STAFF REPORT: DECEMBER 14, 2022 MEETING PREPARED BY: B. BUCKLEY APPLICATION NUMBER: 22-8161 ADDRESS: 1001 E. JEFFERSON AVENUE HISTORIC DISTRICT: PALMS APARTMENTS HISTORIC DISTRICT APPLICANT: THOMAS ROBERTS, AIA PROPERTY OWNER: 81001 JEFERSON LLC DATE OF PROVISIONALLY COMPLETE APPLICATION: NOVEMBER 4, 2022 DATE OF STAFF SITE VISIT: DECEMBER 2, 2022

SCOPE: REHABILITATE EXTERIOR, REPLACE WINDOWS AND DOORS

Figure 3. Examples of existing conditions of the wood double-hung windows

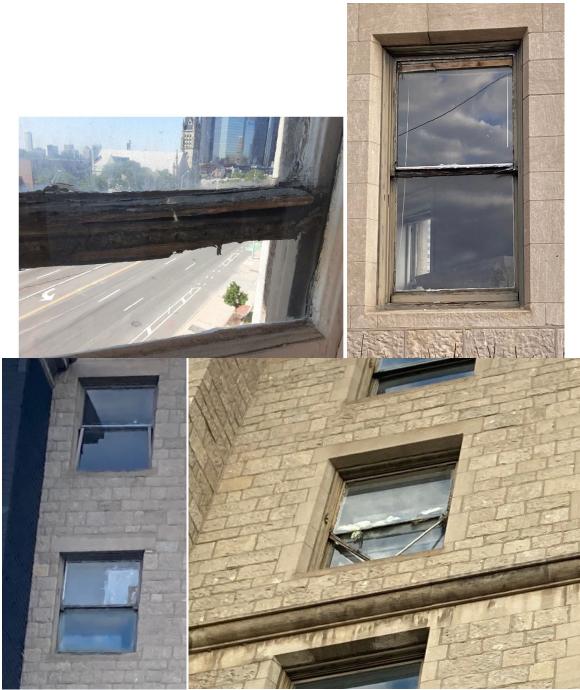
- Photographs from the applicant and from the staff site visit indicate that numerous wood window sashes are decayed beyond repair. Staff was able to observe failing meeting rails, jambs, and sills from the public right-of-way. The applicant submitted quotes for both replacing the existing windows and rehabilitating the existing windows and adding interior storm windows. The applicant provided a quote from BlackBerry Systems for the restoration of the wood windows on the building for approximately 1.66 million dollars. This estimate did not include the replication of any windows deemed beyond repair. The cost estimate from Quaker Windows to furnish new aluminum single-hung windows was approximately 755,000 dollars.

- The replacement of a portion of the glass block windows with single-hung aluminum windows will have a positive effect on the building's integrity.
- The double-hung wood windows proposed for replacement are early or original units. However, evidence suggests that a significant number of the windows have deteriorated to a state where repair is not feasible, and replacement is required. The quotes provided by the applicant further suggest that retaining and restoring the original windows is not reasonably financially feasible. It is staff's opinion that appropriate replacement windows should be considered, and the proposed single-hung aluminum window units are *not an inappropriate* solution. The new windows will have the same overall dimensions are the originals, and the meeting rails, muntins, and mullions will have the same configuration. The windows' material differences and relatively minor differences found in the details of the trim and brick molds should not have a substantial visual effect on the building.

- 1. The double doors at the Rivard Street entrance be retained.
- 2. The HDC is supplied with detailed window drawings that provide a clear comparison between the existing windows and proposed windows as they will be installed in the existing openings. The drawings will provide details for comparison of the overall dimensional changes in the sash, as well as exterior trim and brick mold configurations. If the details do not illustrate an acceptable match that can be approved at the staff level, the windows will be returned to the Commission for review.
